## Product Change Notice (PCN)

**PCN Number:** PCN-0450260R-01

**Product(s) Affected:** MD-SM series (part numbers MD-30SM, MD-40SM, MD-50SM, MD-60SM, MD-70SM, MD-80SM, MD-90SM).

## New Design (MD-30SM, MD-40SM, MD-50SM, MD-60SM, MD-70SM, MD-80SM)

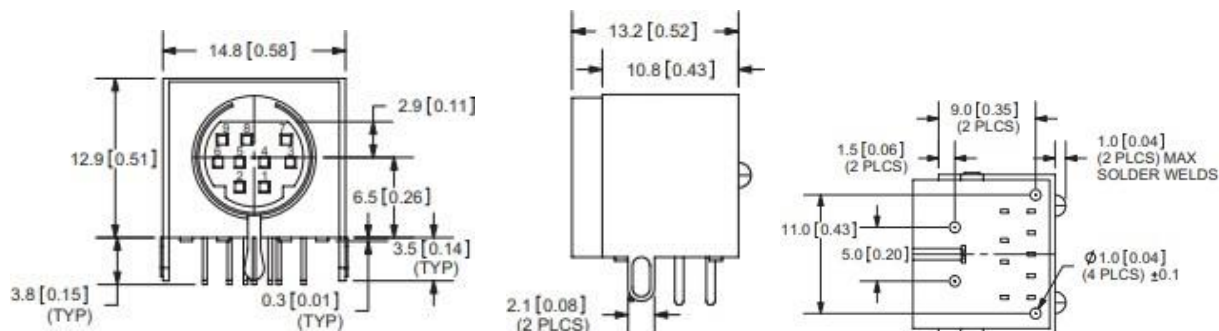
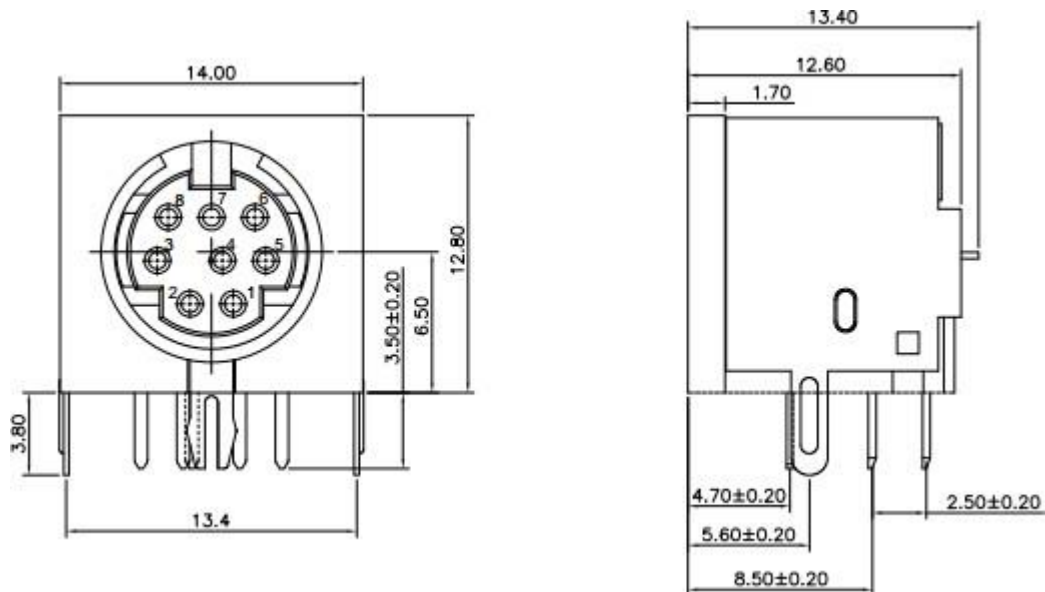
**Description of Change:** minor dimensional changes, and material changes, as shown below.
